Supporting Materials for 803.2dj D2.0 Comment #466

Jeff Slavick - Broadcom

Comment #466

Proposal

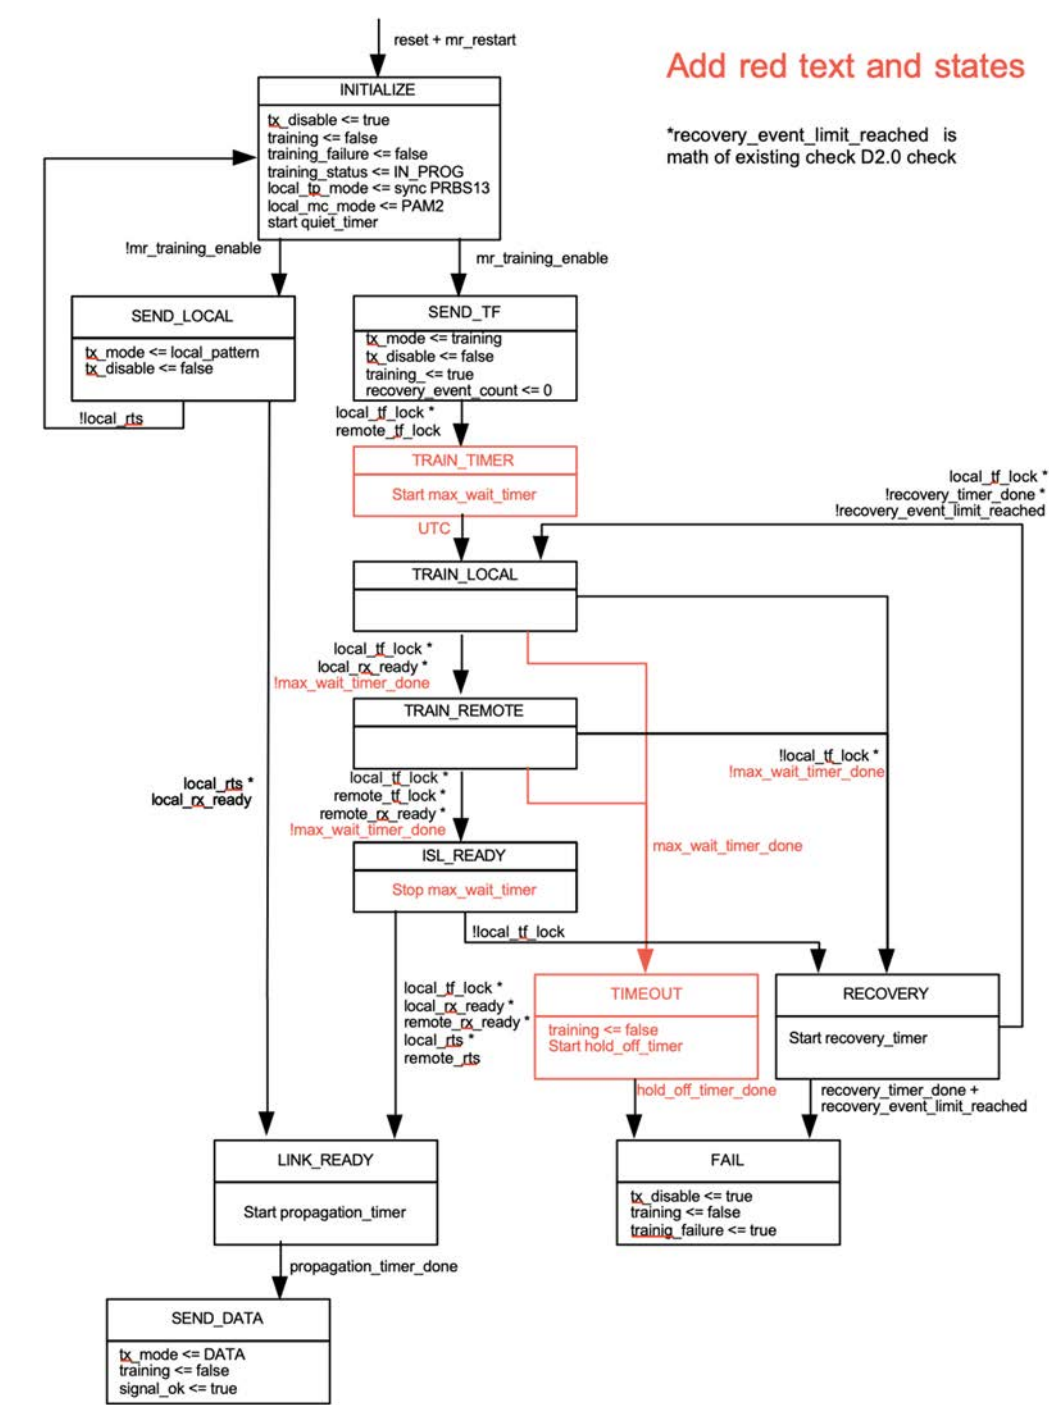
<i>CI</i> 178B	<i>SC</i> 178B.5.1	<i>P</i> 788	<i>L</i> 21	# 466
Slavick, Jeff		Broadcom		
<i>Comment Type</i>	TR	<i>Comment Status</i>	D	<i>(Common) ILT timers</i>
Having an unspecified time limit for rx_ready assertion (from entry to TRAIN_LOCAL) makes for unpredicable link up behaviors. A time limit from the point at which TRAIN_LOCAL is entered to entry to TRAIN_REMOTE will improve predictability of operation which will facilitate predicatble device behaviors.				
<i>SuggestedRemedy</i>				
Presentation for a solution to be provided.

Add in a state to start a hard timeout timer between ST and TRAIN_LOCAL.

Add the TIMEOUT state that sends Training frames for an addition period of time before squelching.

Stop the timer when entering the ISL_READY state.

Timer duration is register controlled with defaults of 12s for all DJ users of 178B but when set to 0, does not generate a done event.
